**RE: Letter of Introduction for Murphy Creek Self Storage and Convenience Store
Site Plan and Plat**

Murphy Creek Parcel 1C
Responses to Initial Comments Dated: December 16, 2010
Submitted: 03/18/2011

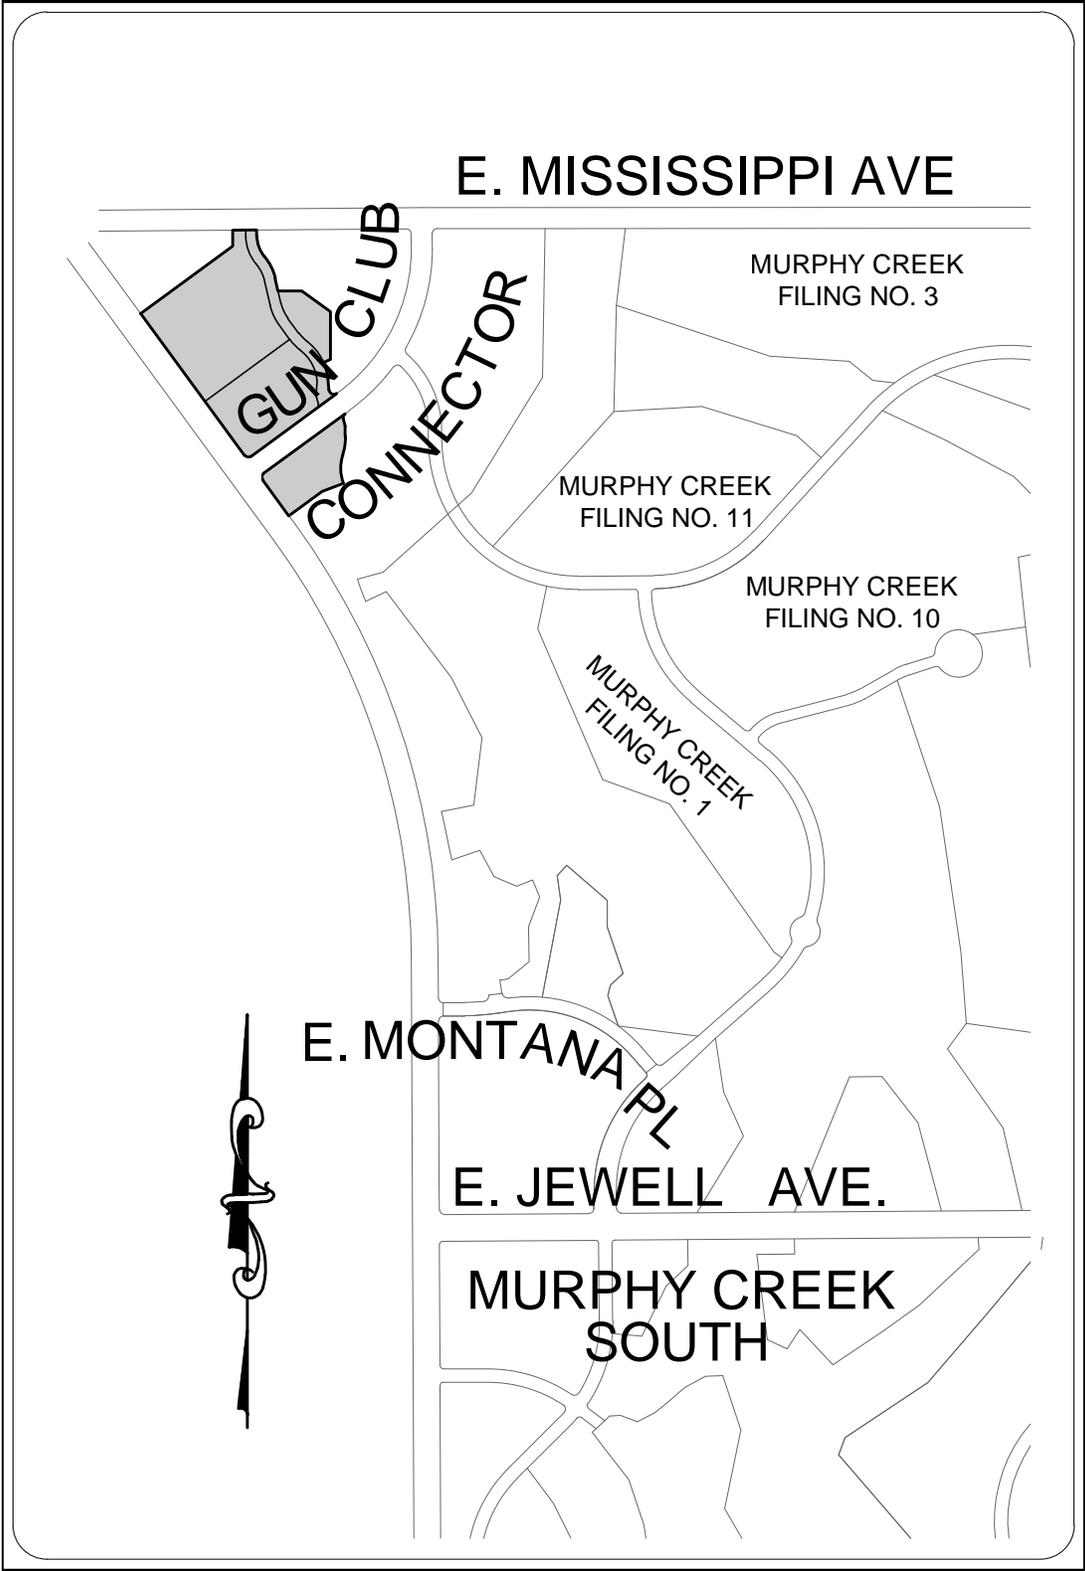
- A fire lane easement will also be required within the RV storage parking/storage area.

Response: Fire lane easements added.
